DATE: March 9, 2021
TO: City of Milwaukie
FROM: Danelle Isenhart, AICP
RE: 4-lot subdivision at 11745 SE Wood Avenue – Pre-application conference request

Preapplication Conference Report

Project ID: 21-002PA

To: City of Milwaukie
From: Alex McGladrey, Deputy Fire Marshal, Clackamas Fire District #1
Date: 4/6/2021
Re: 21-002PA, 4-Lot Subdivision at 11745 SE Wood Ave

4-LOT SUBDIVISION - OPTION A

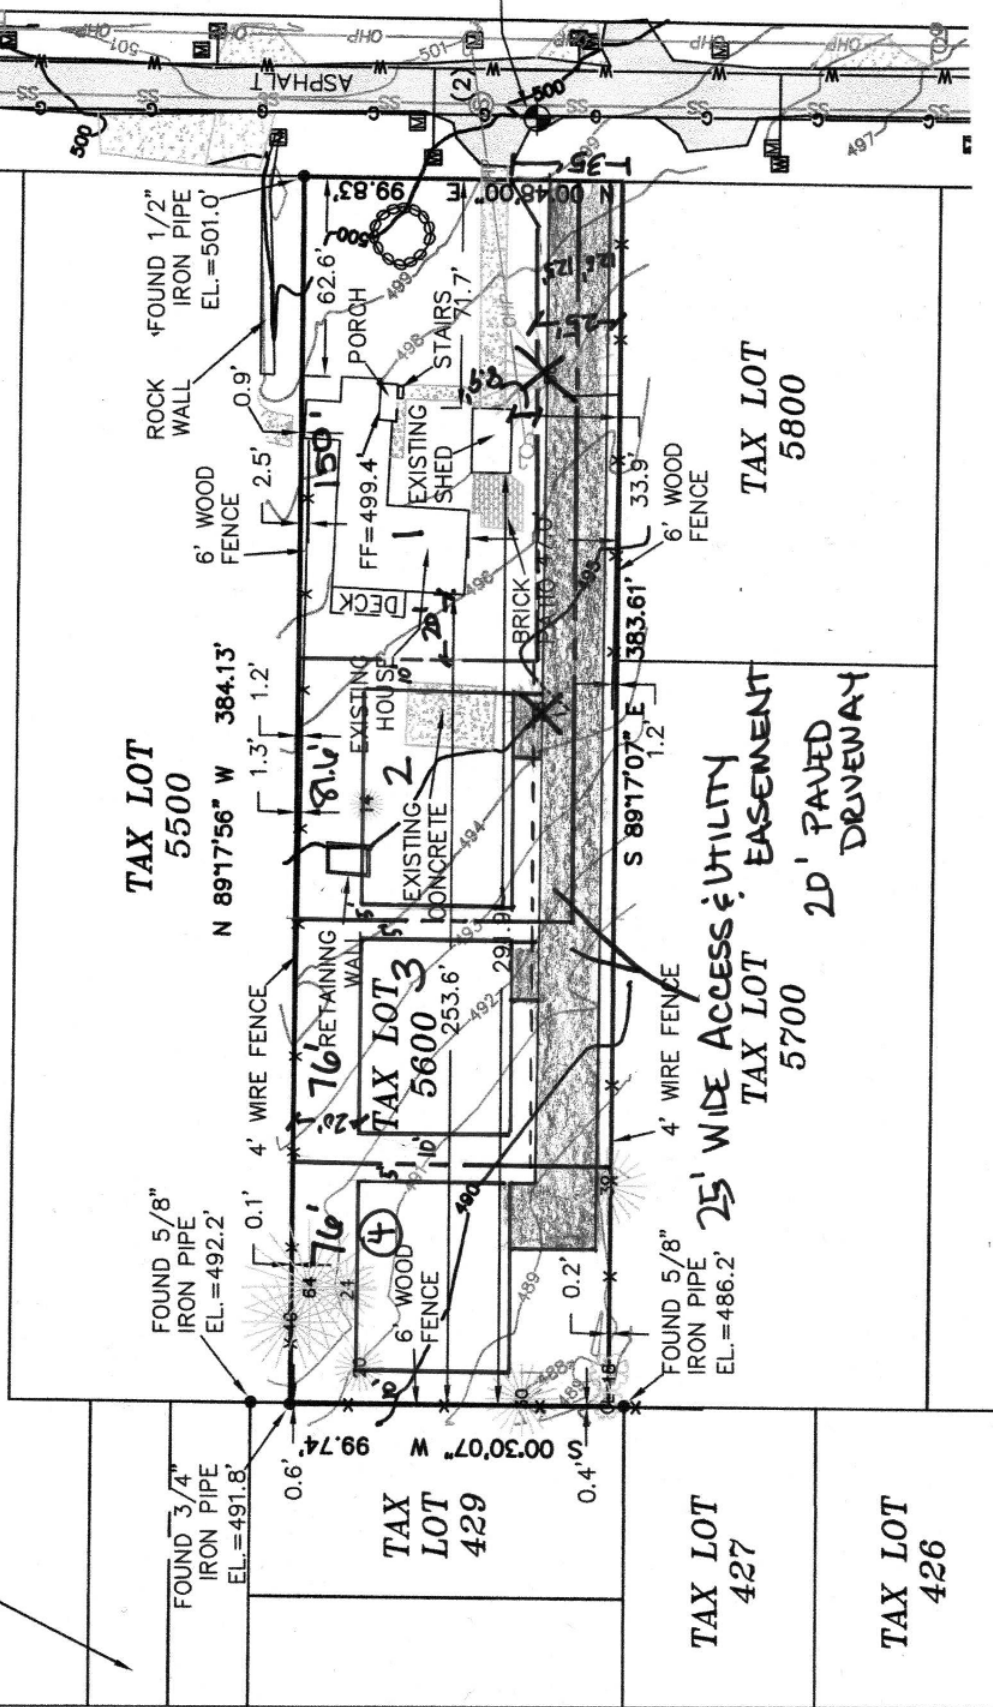
Option A has Lots 1-4 with access to SE Wood Avenue. Lots 2 and 3 are double flag lots. Lot 4 would have access to SE Wood Avenue through an easement over Lots 2 and 3.

1. Is there any required street dedication or improvements on SE Wood Avenue?
2. Is there an issue with any of the lots accessing SE Guido Bocci Drive through an off-site easement (access and utilities)? There appears to be a 1' wide tract at the edge of the SE Guido Bocci Drive right-of-way.
3. Can the double flag in Option A flare out (as shown) to meet the 35' frontage? A double flag with a 35' width the whole length looks to be an issue with the existing driveway and getting a side setback to the existing house. More will be known on options here once survey of the site is complete.
4. Please provide utility information (locations, etc.) for water, sanitary and storm.

<input checked="" type="checkbox"/>	Site Design Standards (MMC 19.504)	<p>Flag lot Design and Development Standards (MMC 19.504.8)</p> <p>Front and rear yard setback: 30 ft Side yard setback: 10 ft</p> <p>Flag lot pole: Abutting flag lots shall have a combined frontage and accessway of 35 ft. For abutting accessways of 2 or more flag lots, the accessway of any individual lot shall not be less than 15 ft.</p> <p>Driveway width – single flag lot: minimum 12 ft, double flag-lot: minimum 16 ft The flag lot driveway shall be consolidated with the driveway on the parent lot to the greatest extent practicable.</p> <p>Fencing and Screening: Flag lots must be screened in accordance with MMC 19.504.8.E to minimize potential adverse impacts to abutting properties.</p> <p>Tree Mitigation: Per MMC 19.504.8.F, all trees 6 in or greater in diameter, as measured at the lowest limb or 4 ft above the ground, whichever is less, shall be preserved.</p> <p>Landscape plan required: Per MMC 19.504.8.G, a landscaping plan shall be submitted to the Planning Manager prior to issuance of a building permit for new construction. Details on the requirements for the landscape plan on in the above MMC subsection.</p> <p>Variances of lot area, lot width, and lot depth standards are prohibited for flag lots.</p> <p>The “pole” section of the flag lot does <u>not</u> count towards lot area.</p>

<input checked="" type="checkbox"/>	Design Standards (MMC 17.28)	<p>General lot design standards in MMC 17.28.040</p> <p>Flag lot design standards in MMC 17.28.050 and MMC 17.28.060</p> <p>Flag lot limitations: Flag lots are prohibited in new subdivisions and subdivisions platted after August 20, 2002 (MMC 17.28.070)</p>
<input checked="" type="checkbox"/>	Preliminary Plat Requirements	<p>Preliminary plat checklist and procedures are listed here: https://www.milwaukieoregon.gov/sites/default/files/fileattachments/planning/page/38211/preliminaryplatchecklist_form0.pdf</p> <p>Submit and meet the requirements with the submittal of a subdivision or partition application.</p>
<input checked="" type="checkbox"/>	Final Plat Requirements (See Engineering Section of this Report)	<p>Final plat checklist and procedures are listed here: https://www.milwaukieoregon.gov/sites/default/files/fileattachments/planning/page/38211/finalplat-checklist_form.pdf</p> <p>Submit and meet the requirements with the final plat application after approval of the subdivision or partition application.</p>

<input checked="" type="checkbox"/>	Access Requirements (MMC 12.16.040)	Driveway must be constructed 7.5-ft from the southern property line. The driveway may widen or angle closer to the property line in accordance with MMC 19.607.
<input checked="" type="checkbox"/>	Clear Vision (MMC 12.24)	Clear vision areas must be maintained around driveway approaches. Coordinate with city staff prior to adding or removing any vegetation in the right-of-way.
Additional Engineering & Public Works Notes		
Utility options vary depending on the design option chosen. Contact and coordinate with the Engineering Department for permitting and SDC fee questions. FILOC rate will be provided soon.

4-LOT SUBDIVISION - OPTION B

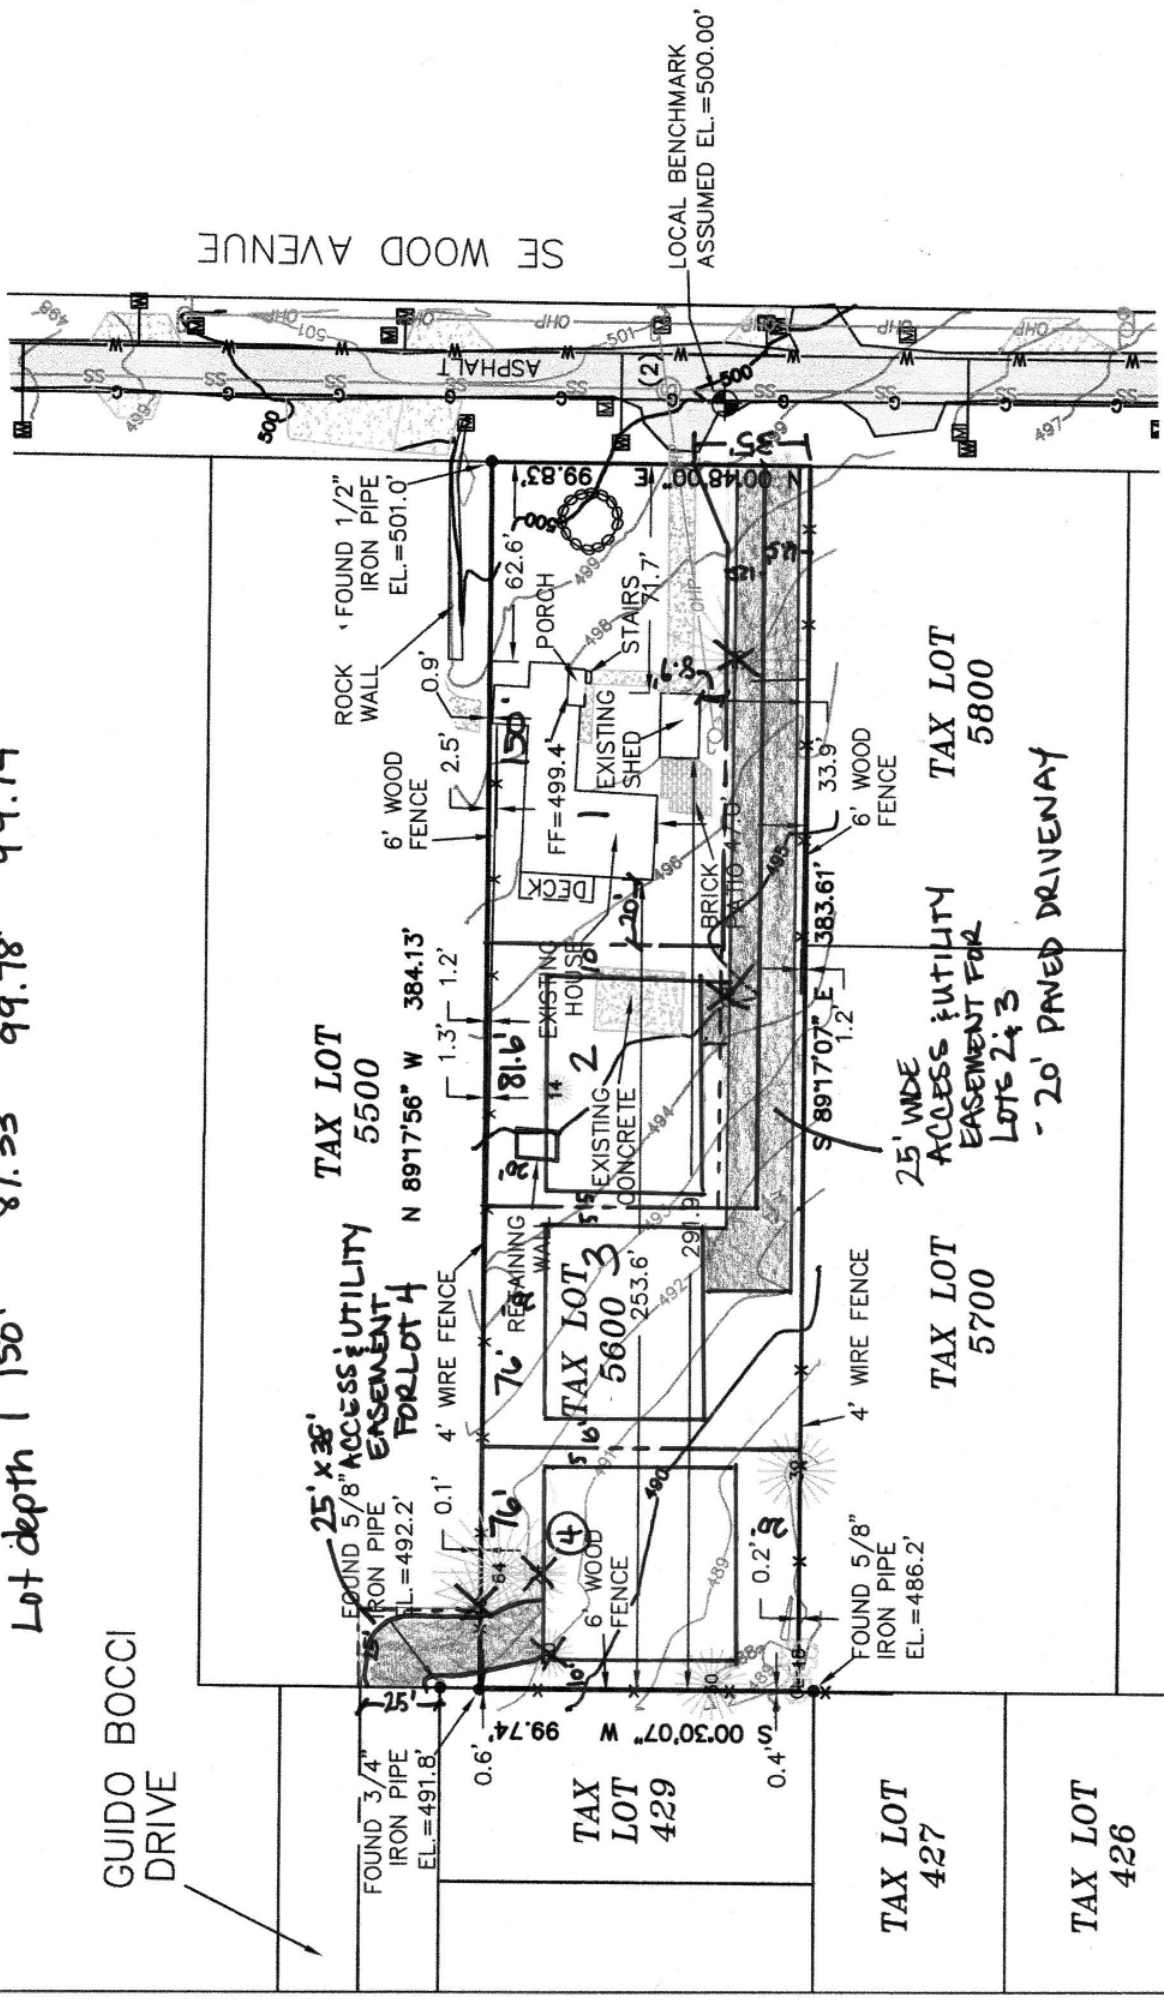
Option B has Lot 1 (existing house) retaining its access onto SE Wood Avenue. Lots 2 and 3 are double flag lots. Lot 4 has access to SE Guido Bocci Drive through an easement on the property to the north.

4-LOT SUBDIVISION - OPTION C

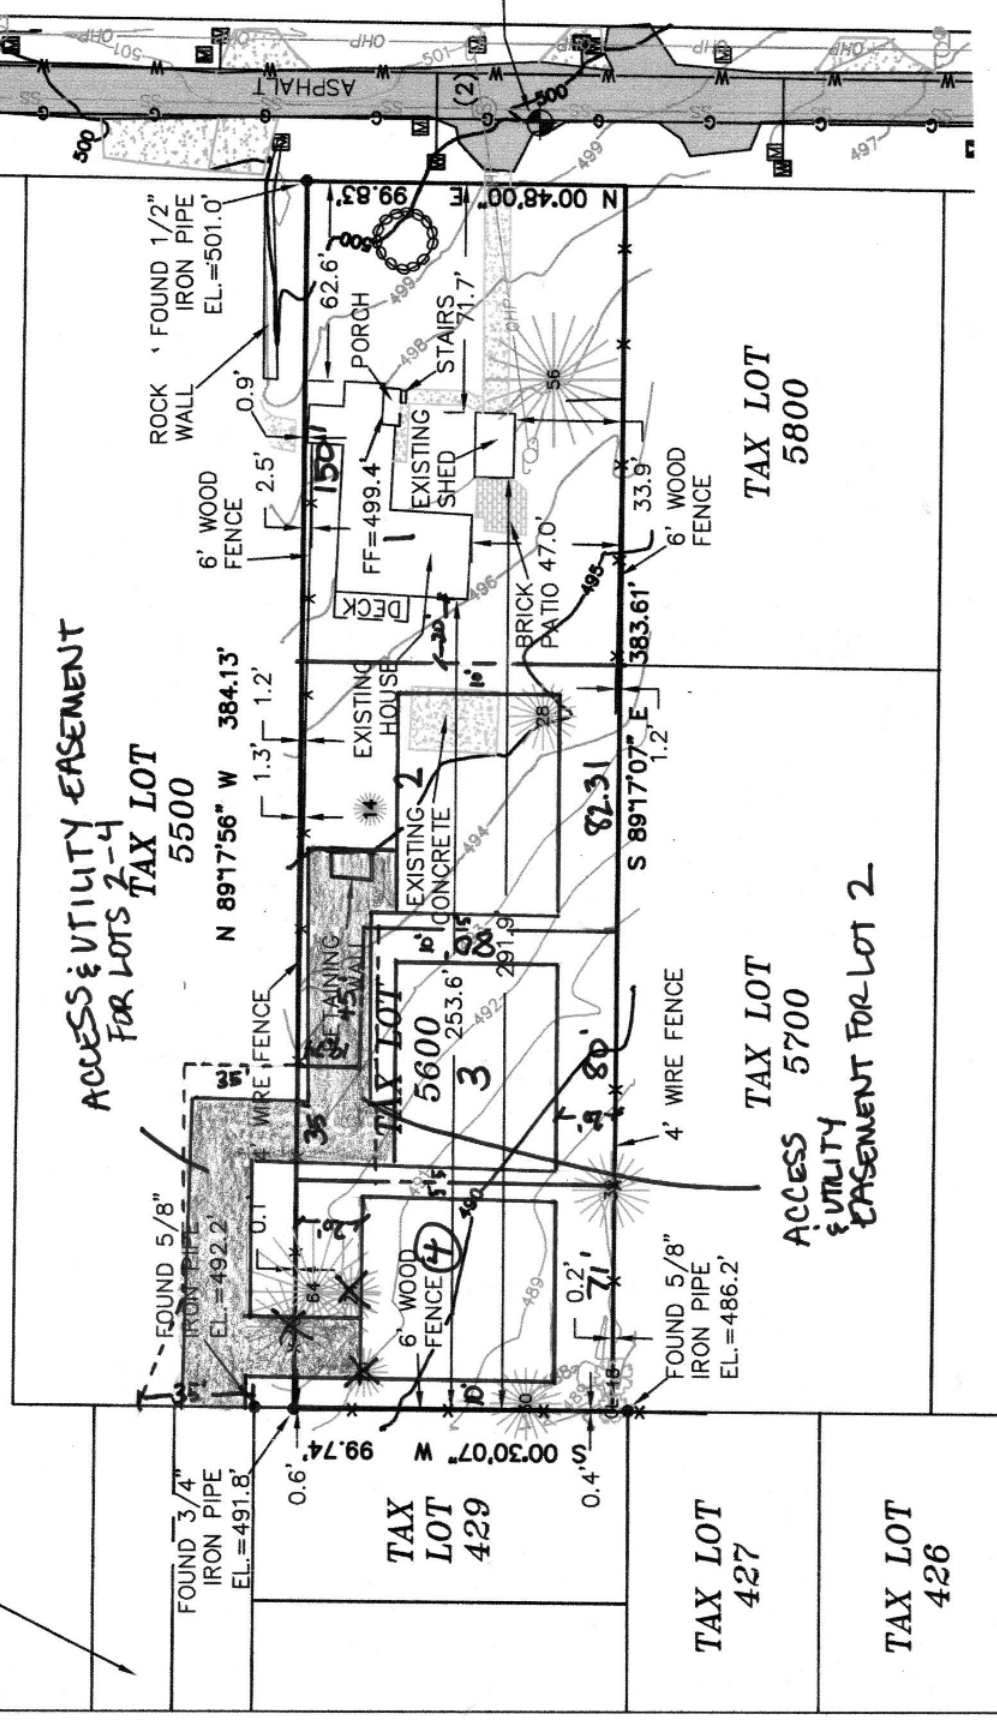
Option B has Lot 1 (existing house) retaining its access onto SE Wood Avenue. Lots 2-4 have access to SE Guido Bocci Drive through an easement on the property to the north.
